## **Access Compliance Report Public Rights-of-Way** (Curb Ramps)

Cross Street: N/A Intersection ID: 10025513 Main Street: E\_MOREHEAD\_ST Location: W **Overall Compliance: No** ADA ID: F61236FBF341 Ramp Type: Directional1 Initial Pass/Fail: Fail Severity Score: 33.75

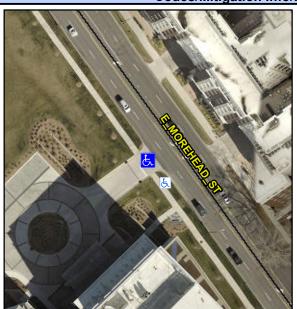
Possible Solutions:	Cor
Remove & Replace Entire Ramp.	N/A
·	No
	Yes
	No
	N/A
	N/A
Surveyor Notes:	N/A
N/A	N/A
	N/A
	N/A
	N/A
PROW/ADA:	N/A
R304.5.1, R304.5.3	N/A
	N/A
	N/A
	N/A

Comp	liance Description	Data	Comp	liance Description	Data
N/A	Ramp Length (in)	56.0	N/A	Grade Break?	N/A
No	Ramp Width (in)	47.0	N/A	Grade Break Slope (%)	0.0
Yes	Ramp Slope (%)	5.3	N/A	Grade Break XSlope (%)	0.0
No	Ramp XSlope (%)	8.1			
N/A	Flare Type LT	N/A	N/A	Flare Type RT	N/A
N/A	Flare Slope LT (%)	N/A	N/A	Flare Slope RT (%)	0.0
N/A	Flare Traversable LT?	N/A	N/A	Flare Traversable RT?	N/A
N/A	Landing Length (in)	0.0	N/A	DWS Provided?	N/A
N/A	Landing Width (in)	0.0	N/A	DWS Contrast?	N/A
N/A	Landing Slope (%)	0.0	N/A	DWS Length (in)	N/A
N/A	Landing X Slope (%)	0.0	N/A	DWS Full Width?	N/A
N/A	Landing Curb? (Y/N)	N/A	N/A	DWS Offset LT (in)	N/A
N/A	Shared Landing?	N/A	N/A	DWS Offset RT (in)	N/A
N/A	Gutter Ponding?	0.0	N/A	Gutter Slope (%)	N/A
N/A	Gutter Lip Ht (in)	0.0	N/A	Gutter X Slope (%)	N/A
N/A	Painted X Walk1?	No		Road Slope (%)	5.4
	X Walk 1 Direction	To SE		Road X Slope (%)	5.
	X Walk 1 Width (in)	N/A		Clear Space?	N/A

IN/
		N/
PROW/ADA:		N/
R304.5.1, R304.5.3		N/
		N/
		N/
Total Cost:	\$ 1600.00
